Access Compliance Report

Public Rights-of-Way

(Curb Ramps)

Intersection ID: 24825	Main Street: CHOATE_CR	Cross Street: MOSS_RD	Location: NW
ADA ID: 4EF89C8C1B84	Ramp Type: PerpDiag	Initial Pass/Fail: Fail	Overall Compliance: No
Severity Score: 12.5			
Codes/Mitigation Info/Possible Solution		Field Measurements/Component Compliance

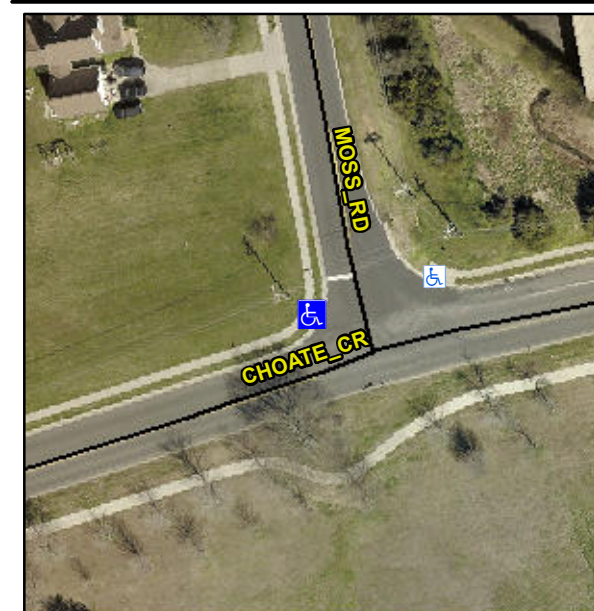
Remove & Replace Curb Ramp With Two New Directional Ramps or Equivalent.

R304.2.2

Compliance	Description	Data	Compliance	Description	Data
N/A	Ramp Length (in)	47.0	No	Ramp Slope (%)	10.7
Yes	Ramp Width (in)	48.0	Yes	Ramp XSlope (%)	0.5
N/A	Flare Type LT	N/A	N/A	Flare Type RT	N/A
N/A	Flare Slope LT (%)	N/A	N/A	Flare Slope RT (%)	N/A
N/A	Flare Traversable LT?	N/A	N/A	Flare Traversable RT?	N/A
N/A	Landing Length (in)	N/A	N/A	DWS Provided?	N/A
N/A	Landing Width (in)	N/A	N/A	DWS Contrast?	N/A
N/A	Landing Slope (%)	N/A	N/A	DWS Length (in)	N/A
N/A	Landing X Slope (%)	N/A	N/A	DWS Full Width?	N/A
N/A	Landing Curb? (Y/N)	N/A	N/A	DWS Offset (in)	N/A
N/A	Shared Landing?	N/A			
N/A	Gutter Ponding?	N/A	N/A	Gutter Slope (%)	N/A
N/A	Gutter Lip Ht (in)	N/A	N/A	Gutter X Slope (%)	N/A
N/A	Painted X Walk1?	No	N/A	Painted X Walk2?	No
	X Walk 1 Direction	To S		X Walk 2 Direction	To E
N/A	X Walk 1 Width (in)	N/A	N/A	X Walk 2 Width (in)	N/A
	X Walk 1 Slope (%)	1.1		X Walk 2 Slope (%)	1.1
	X Walk 1 X Slope (%)	0.3		X Walk 2 X Slope (%)	3.5
